**REVIEW OF HYDRAULIC MODELING
MISSOURI RIVER BNSF BRIDGE – BISMARCK / MANDAN, ND**

September 18, 2020

Table 5-4

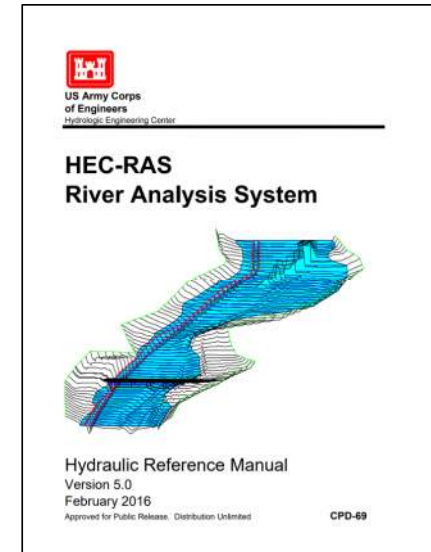
Because the BNSF Preferred Option has more blockage, the only way the Yarnell method will show “no rise” is to choose Yarnell coefficients where with the coefficient for the existing bridge is higher (less efficient) than the Preferred Option.

Review of BNSF Concept 3 – Existing Bridge Remains / New Bridge 42.5 Feet Upstream

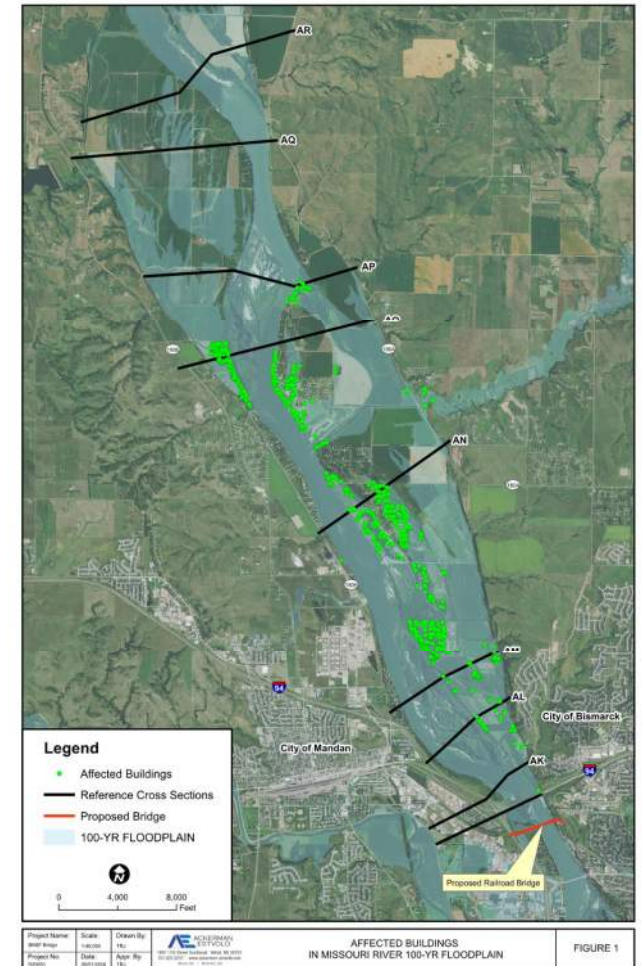
- ❖ Results of One-Dimensional HEC-RAS Modeling & Mapping
 - ❖ 0.03-ft upstream rise upstream of bridge
 - ❖ 552 structures potentially affected
 - ❖ All 552 structures are currently in the 100-year floodplain
 - ❖ 317 structures the rise is less than 3/8 inch
 - ❖ 235 structures the rise is less than 1/4 inch

Case B Mitigation – Base Flood Elevation Rise 0.02'

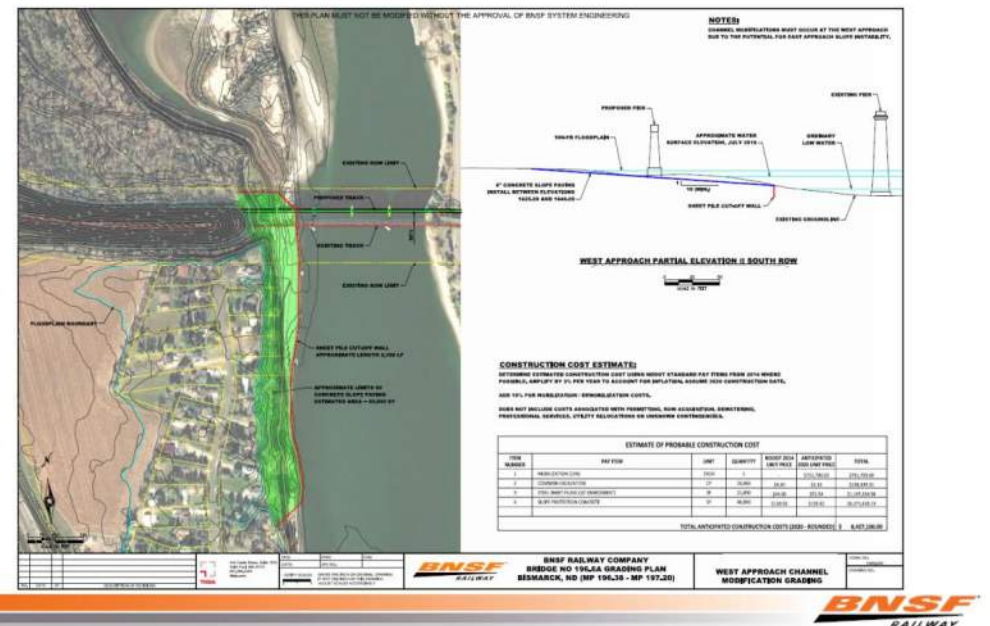
- ❖ Reduce water surface profile to eliminate modeled rise
- ❖ BNSF evaluated solution to pave ¼ to ½ mile of beach to mitigate 0.02' rise
- ❖ ~\$8.4 M Cost
- ❖ More expensive to mitigate 0.03' rise
- ❖ Likely socially and environmentally unacceptable

BNSF Concept 3 Impact Mitigation – Alternative Mitigation Concept

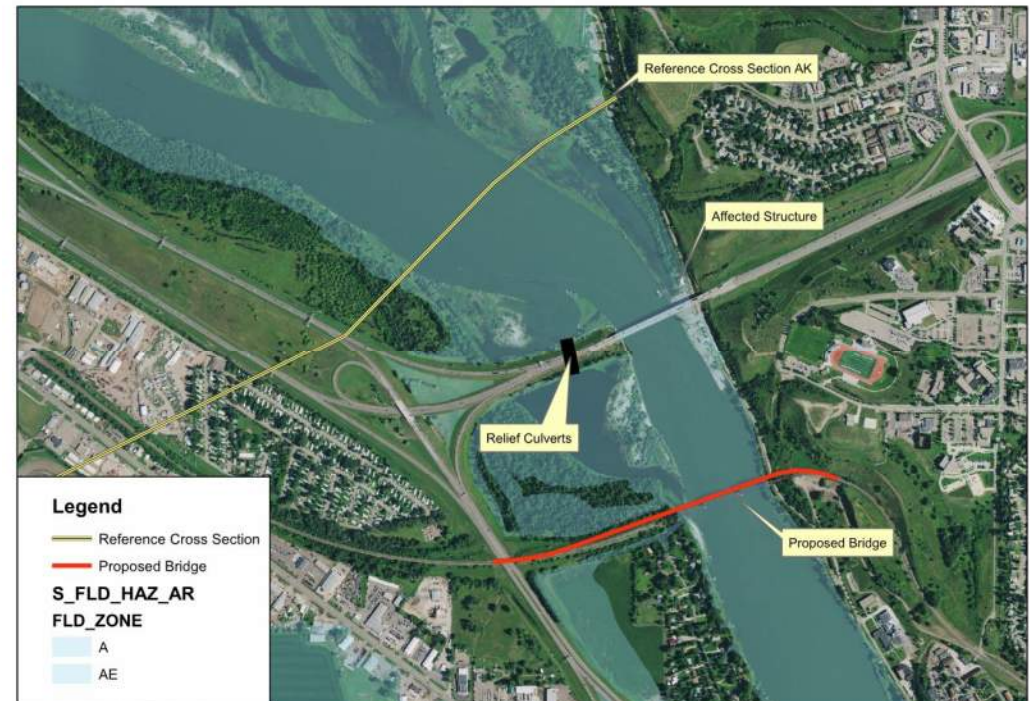
- ❖ Results Based on One-Dimensional HEC-RAS Model
 - ❖ Reduce water surface profile to eliminate modeled rise
 - ❖ Provide three 12-ft relief culverts through Interstate 94 embankment
 - ❖ Cost \$5M to \$10M
 - ❖ Enhance floodplain hydraulics
 - ❖ Provide wildlife passage across I-94 corridor
 - ❖ Possibly affect 1 structure – increase BFE less than 1/2-inch on posts of deck/boat dock

Existing Bridge and New Bridge 42.5-feet Upstream - Two-Dimensional Modeling

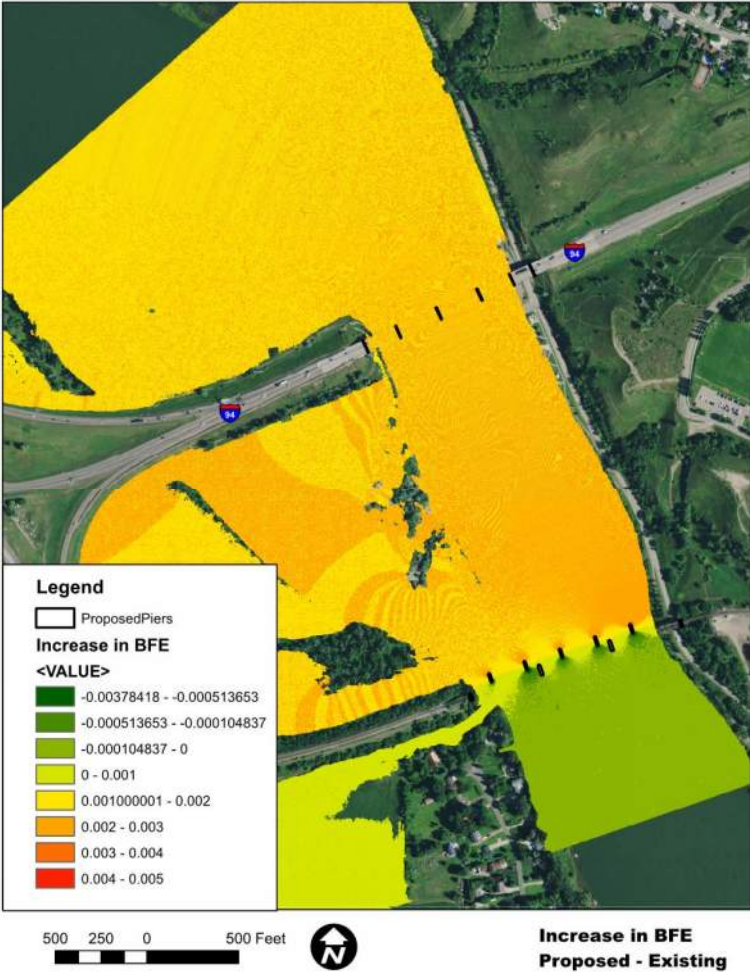
- ❖ Shows less than 0.003-ft upstream rise (1/32 of an inch)

Alternative Hydraulic Modeling Approach (2-Dimensional Modeling)

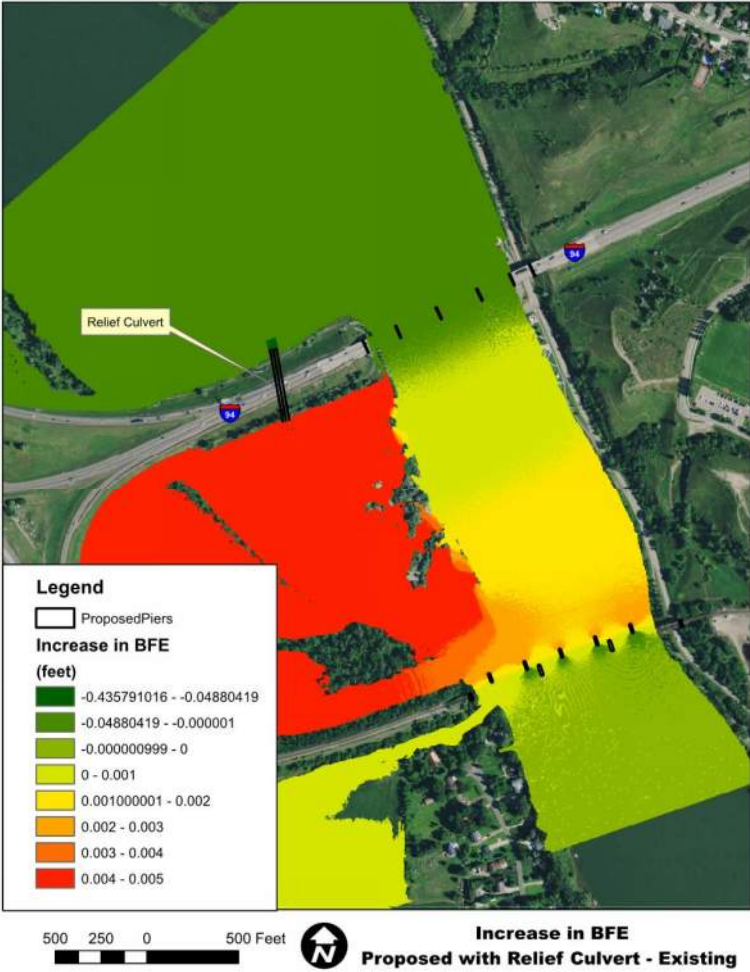
- ❖ Single relief culvert mitigates rise upstream of Interstate 94
